GRADING AND EROSION CONTROL PLANS FOR WALDEN SANITATION DISTRICT WASTEWATER TREATMENT PLANT PROJECT EL PASO COUNTY, COLORADO MARCH 2026

EPC DPW Stormwater did not fully review the last GEC submission since it was not associated with a stormwater permit. New information provided with this submission has triggered the requirement for an ESQCP, so full comments will be provided at this time. See comment on sheet 12 for additional information.

PCD PROJ. NO. : PPR2538

SHEET TITLE:
 LAGOONS CLOSURE PLAN
 PROJECT NUMBER: #3774
 SCALE: 1"=100'
 SHEET: C11

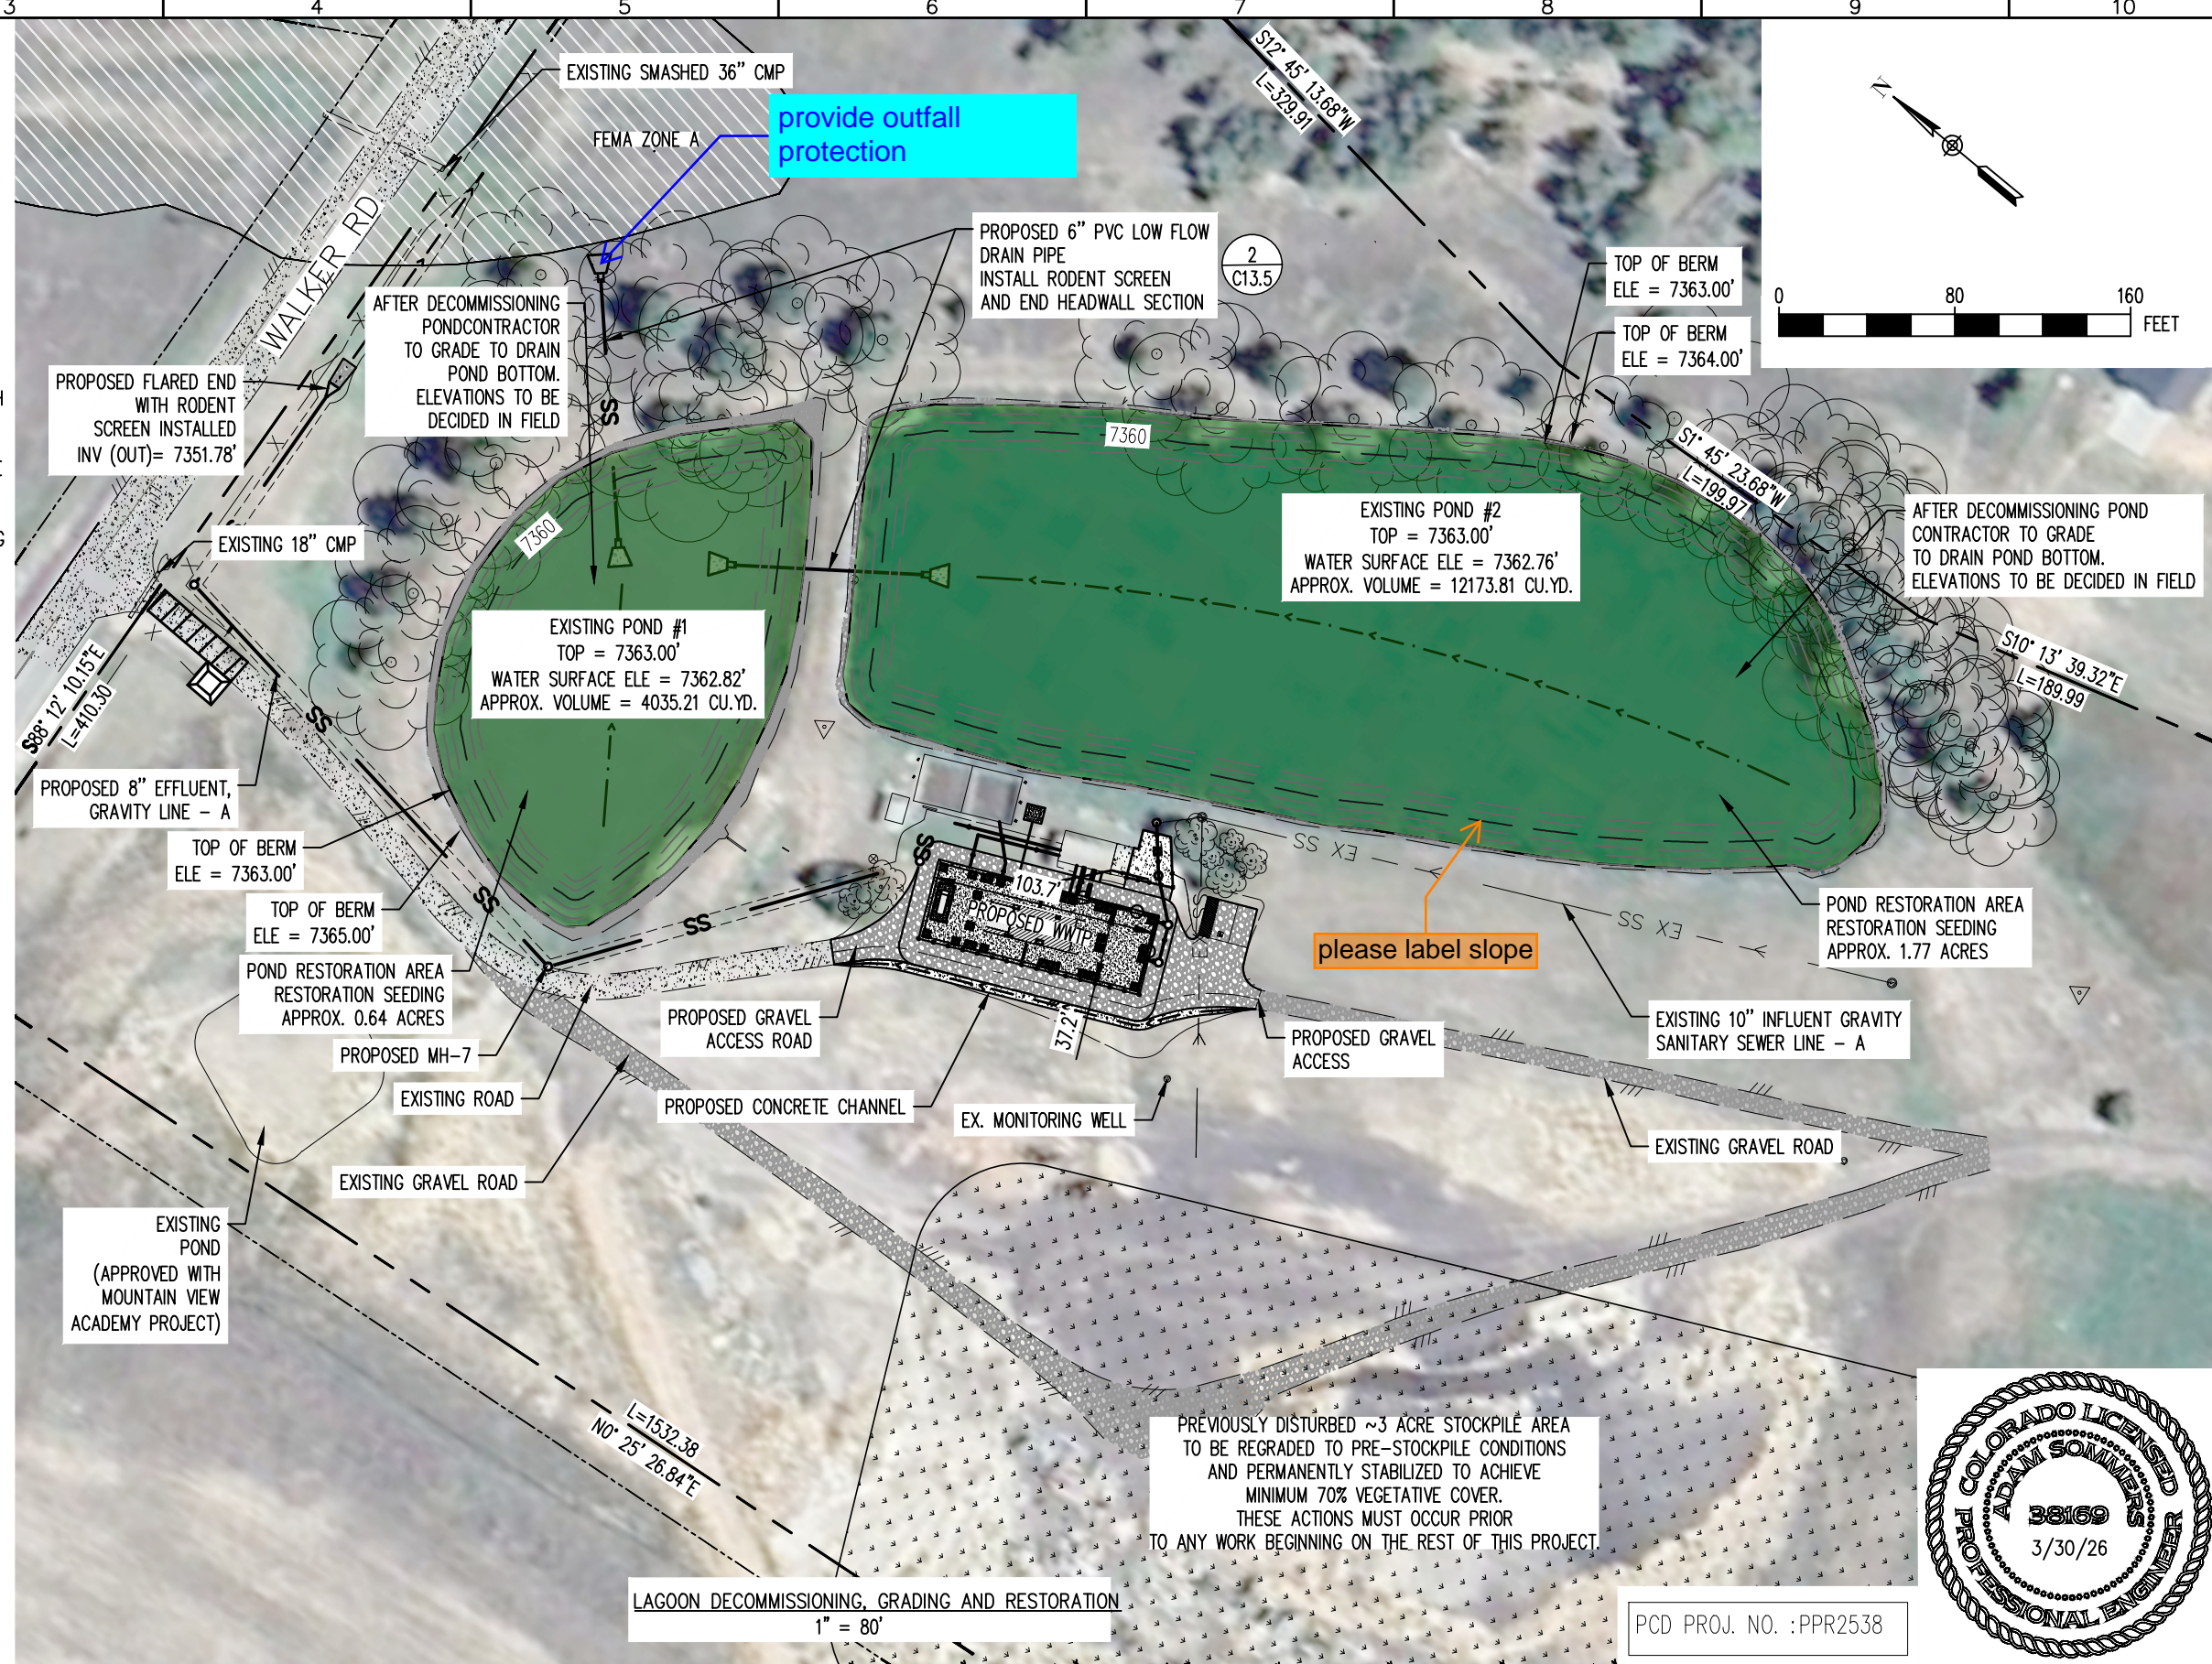
Can this information be added to the Pond Reclamation plan document

Show stockpile area on GEC plan

Clarify when drain pipes will be installed

Please provide verification letter from EPC Health and CDPHE that this reclamation plan is permitted (KP)

STABILIZED CONSTRUCTION ENTRANCE
NTS (1) C13

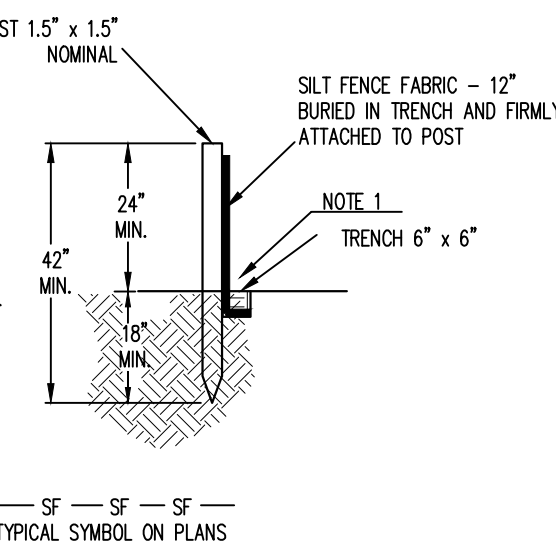
Replace with EPC approved VTC detail (VT-1 and VT-2 in DCMv2, Chap 3.3) or revise to be 75ft min length.
